ADDENDUM NUMBER ONE

**DARLA MOORE SCHOOL OF BUSINESS CONSTRUCTION – BP-2 STRUCTURE
UNIVERSITY OF SOUTH CAROLINA
STATE PROJECT NUMBER H27-6069-AC-2**

DATE OF ISSUE: January 12, 2012

PARTIAL COLUMN SCHEDULE			COLUMN MARKS	LEVEL
A-12	K-01	G-04 G-09 L-04 L-09		LEVEL 5 MAIN ROOF
				LEVEL 4
				LEVEL 3
				LEVEL 2
				LEVEL 1
				PEDESTAL SIZE VERT. REINF. TIES TIE DETAIL CONC. STRENGTH LEVEL 0
				DOWELS
				REMARKS
BP2			BP2	BASE PLATE MARK

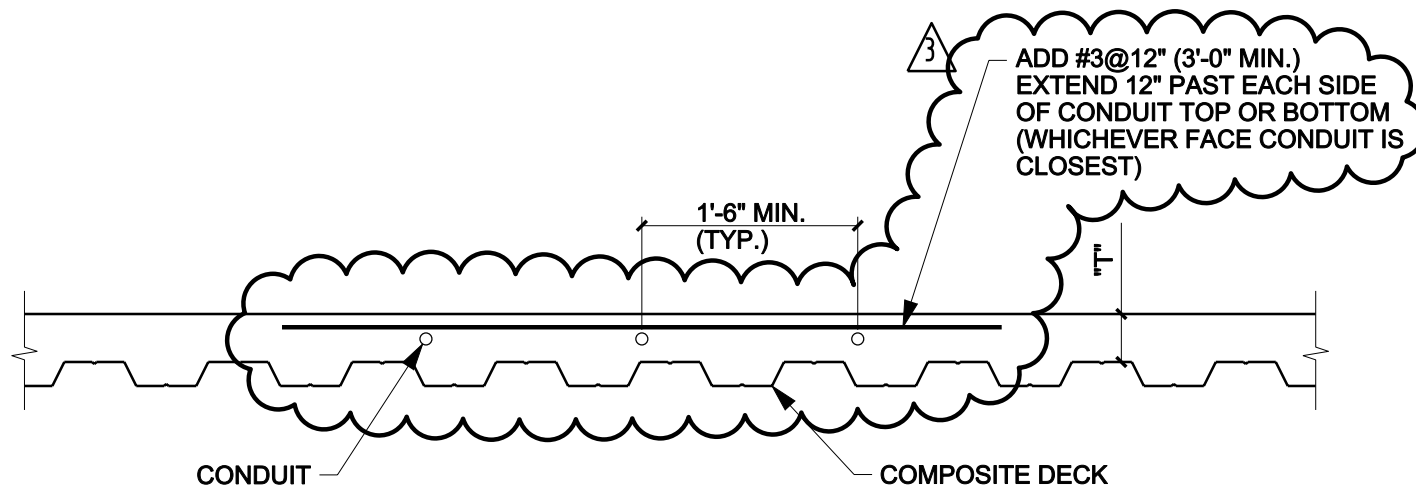
- 40. Detail sheet S2106: Refer to attached sketch S-SK-014 and S-SK-015 and S-SK-016. Revised detail 14 and added new details 15 and 16.
- 41. Column schedule sheet S3101: Refer to attached sketch S-SK-017 – revised column schedule for added column at K-01.
